K-Tex Industrial Co. Ltd

Plot No.76, Road-5, Block-k Rupnagar Industrial Area, Sector-2, Mirpur, Dhaka-1216
(23°48'42"N, 90°21'27"E)
7th February 2015

Observations

Heavily-loaded column in toilet area

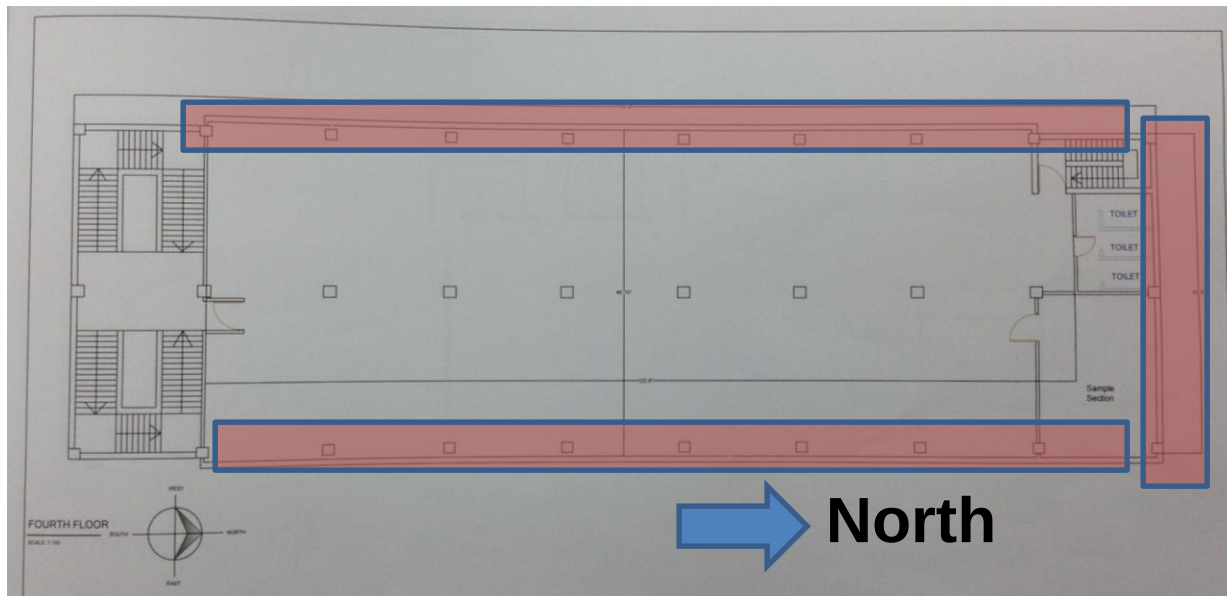
Column in toilet area appears to be loaded in excess of normal stress limits

ITEM 1: Columns at ground floor level appear to be stressed in excess of normal design limits

Item No.	Observation	Recommended Action Plan	Recommended Timeline
1	Columns at ground floor level appear to be stressed in excess of normal design limits	Building Engineer to review design, loads and columns stresses in area identified in full report.	6-weeks
2	Columns at ground floor level appear to be stressed in excess of normal design limits	Verify insitu concrete strengths (using min. 4 no. 100mm dia. Cores) and existing reinforcement for all columns.	6-weeks
3	Columns at ground floor level appear to be stressed in excess of normal design limits	Produce and actively manage a loading plan for all floor plates within the factory giving consideration to floor capacity and column capacity.	6-weeks
4	Columns at ground floor level appear to be stressed in excess of normal design limits	Building Engineer to confirm that column strengths and reinforcement surveys show the columns as adequate for loading as shown in loading plans.	6-months

5	Columns at ground floor level appear to be stressed in excess of normal design limits	Implement load management plan	6-months

First floor plan

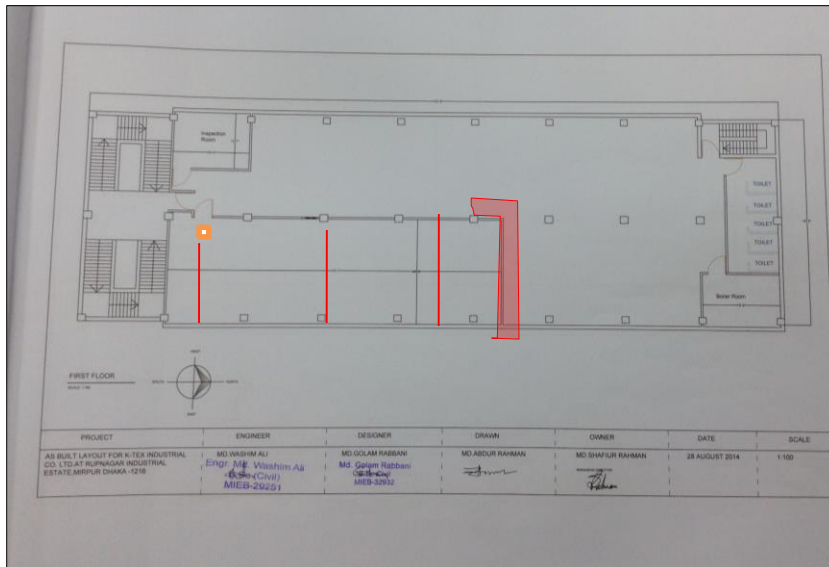
Cantilever not mentioned in the drawing

Cantilever

ITEM 2: Differences between drawings and as-built structure

Item No.	Observation	Recommended Action Plan	Recommended Timeline
6	Differences between drawings and as-built structure: * Cantilevered suspended floor on sides and rear * Wall layout on floors * Rooftop water tank locations	Building Engineer to survey as-constructed building	6-weeks
7	Differences between drawings and as-built structure: * Cantilevered suspended floor on sides and rear * Wall layout on floors * Rooftop water tank locations	Amend structural drawings to reflect as-constructed floor plates	6-weeks
8	Differences between drawings and as-built structure: * Cantilevered suspended floor on sides and rear * Wall layout on floors * Rooftop water tank locations	Update loading plan (ref. Item 1) as required.	6-months
9	Non-engineered and poorly-constructed lightweight roofs to dining area and stair cores	Building Engineer to review the structure to the dining room and the stair core roofs.	6-weeks

Roof plan

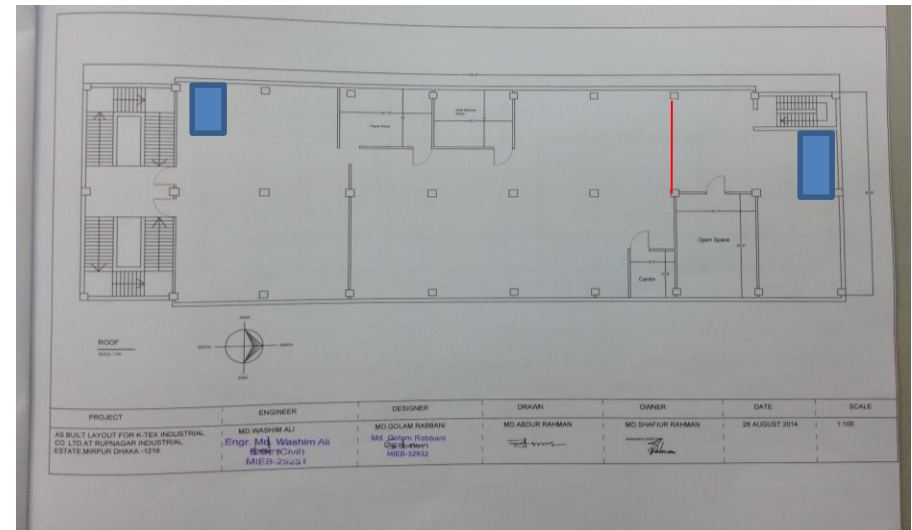
Wall layout missing

Water tank positions are missing from the drawing

Water tanks on the rear side (Empty)

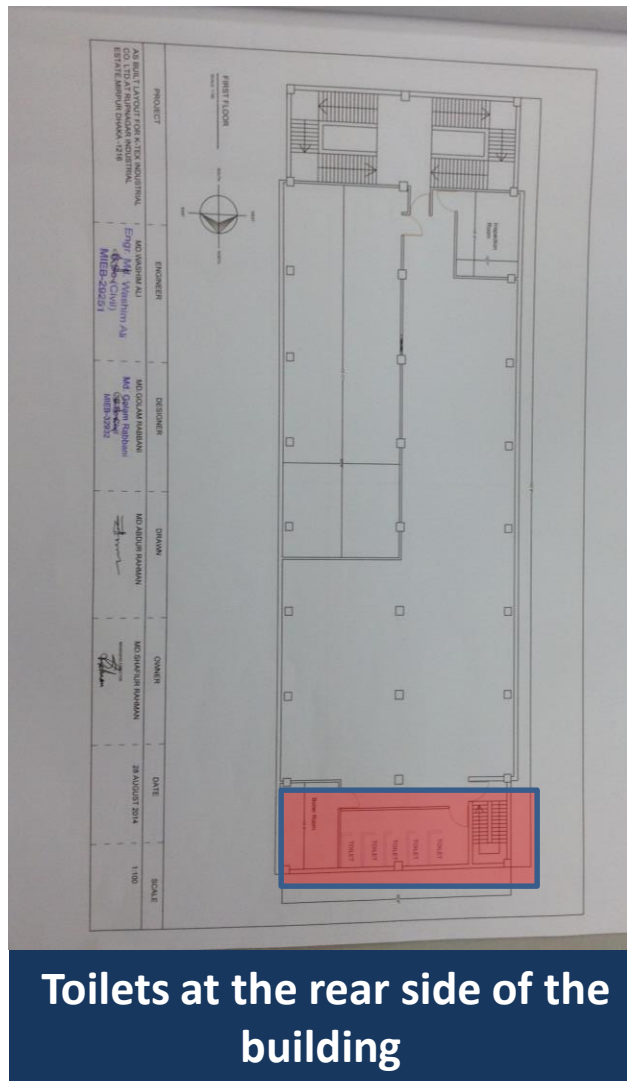
**Water tanks on roof at rear, empty at
time of inspection**

Water tanks were empty at the time of inspection.

ITEM 4: Water tanks noted on roof at rear, empty at time of inspection

Item No.	Observation	Recommended Action Plan	Recommended Timeline
11	Water tanks noted on roof at rear, empty at time of inspection	Keep water tanks empty (as on the day of the inspection)	6-weeks
12	Water tanks noted on roof at rear, empty at time of inspection	Keep water tanks empty	6-months
13	Water tanks noted on roof at rear, empty at time of inspection	Remove tanks	6-months
14	Heavily-loaded cantilever slab due to build-up in toilet area in rear of the building	Building Engineer to review the loading on the cantilever slab in the toilet area	6-weeks
15	Heavily-loaded cantilever slab due to build-up in toilet area in rear of the building	Carry out any remedial works arising from the engineering review	6-months
16	Storage of fabric on 4th floor	Continue to restrict loading on floors to 2kPa.	6-months
17	Poorly-fixed hoist on the roof	Hoist to be removed from the roof	6-months

**Heavily-loaded cantilever slab due to
build-up in toilet area in rear of the
building**

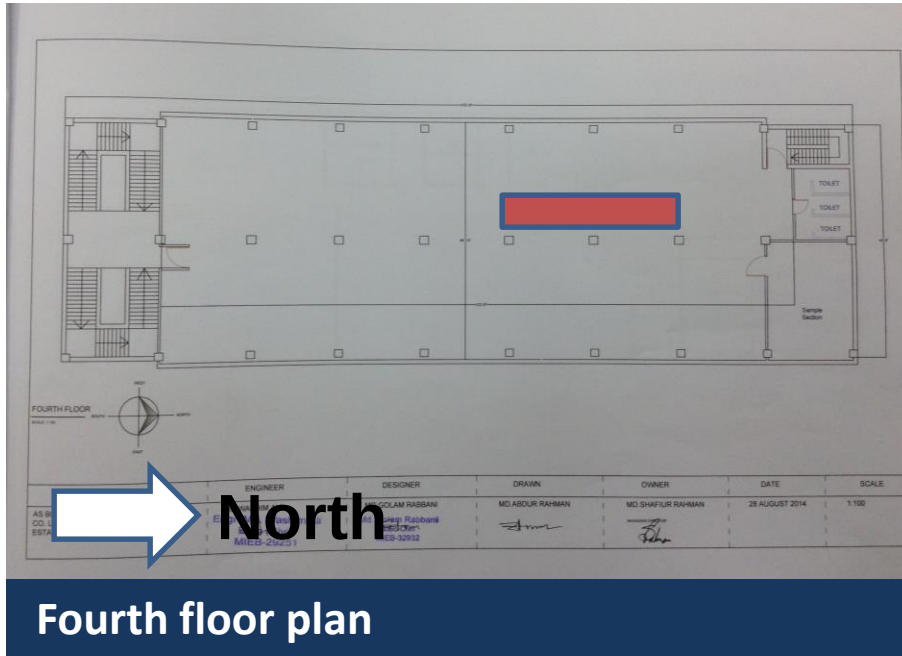
ITEM 5: Heavily-loaded cantilever slab due to build-up in toilet area in rear of the building

Hoist position on the roof

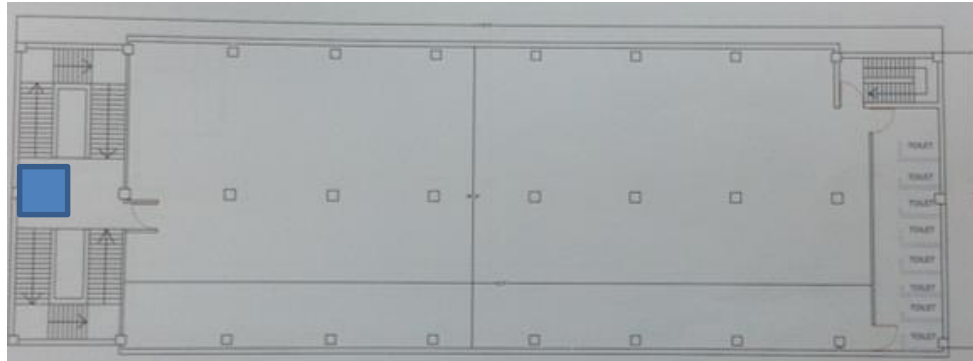
Poorly-fixed hoist on the roof

Hoist on the front side of the roof

ITEM 7: Poorly-fixed hoist on the roof
